# Access Compliance Report

## Public Rights-of-Way

Intersection ID: 50586	Main Street: LONGSTRAW_RD	Cross Street: DOWNY_BIRCH_RD	Location: SW
ADA ID: 27587FD32BEF	Ramp Type: Perp	Initial Pass/Fail: Pass	Overall Compliance: No
		Severity Score: 5

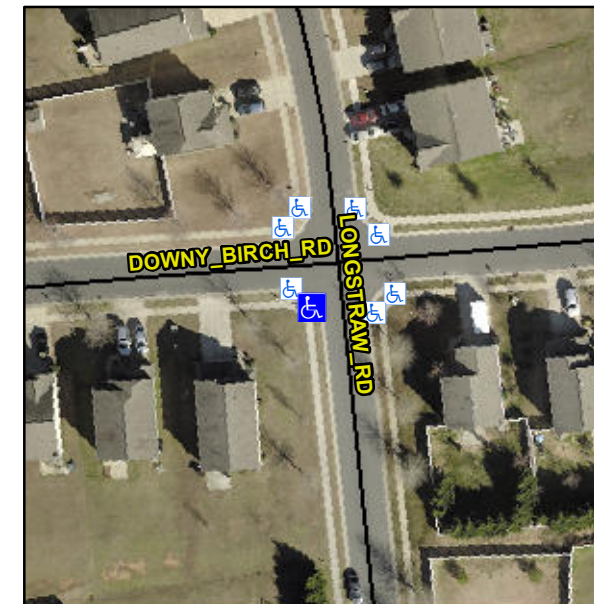
**R304.2.2-Perp, R304.3.2-Para,  
R305.2, R304.5.4**

Compliance	Description	Data	Compliance	Description	Data
N/A	Ramp Length (in)	48.5	Yes	Ramp Slope (%)	5.4
Yes	Ramp Width (in)	48.0	Yes	Ramp XSlope (%)	1.1
N/A	Flare Type LT	Sloped	N/A	Flare Type RT	N/A
N/A	Flare Slope LT (%)	2.3	N/A	Flare Slope RT (%)	4.1
N/A	Flare Traversable LT?	No	N/A	Flare Traversable RT?	No
Yes	Landing Length (in)	48.0	Yes	DWS Provided?	Yes
Yes	Landing Width (in)	48.0	Yes	DWS Contrast?	Yes
No	Landing Slope (%)	2.8	Yes	DWS Length (in)	24.5
Yes	Landing X Slope (%)	1.3	Yes	DWS Full Width?	Yes
N/A	Landing Curb? (Y/N)	No	No	DWS Offset (in)	6.5
N/A	Shared Landing?	Yes			
Yes	Gutter Ponding?	No	No	Gutter Slope (%)	13.4
Yes	Gutter Lip Ht (in)	0.0	Yes	Gutter X Slope (%)	1.1
N/A	Painted X Walk1?	No	N/A	Painted X Walk2?	N/A
	X Walk 1 Direction	To E		X Walk 2 Direction	N/A
N/A	X Walk 1 Width (in)	N/A	N/A	X Walk 2 Width (in)	N/A
	X Walk 1 Slope (%)	1.9		X Walk 2 Slope (%)	N/A
	X Walk 1 X Slope (%)	2.4		X Walk 2 X Slope (%)	N/A

N/A	Ramp inside XWalk1?	N/A	N/A	Ramp inside XWalk2?	N/A
	Road Slope (%)	N/A	N/A	Clear Space?	Yes
	Road X Slope (%)	N/A	N/A	Clear Space to XWalk (in)	N/A
Yes	Any Obstructions?	No	Yes	Storm Grate/Utility Hazard?	No
	Obstruction Type			Storm Grate/Utility Type	
		N/A			N/A
			Yes	Surface Condition? (G/P)	Good

**Remove & Replace Entire Ramp.  
Remove & Replace Gutter.**
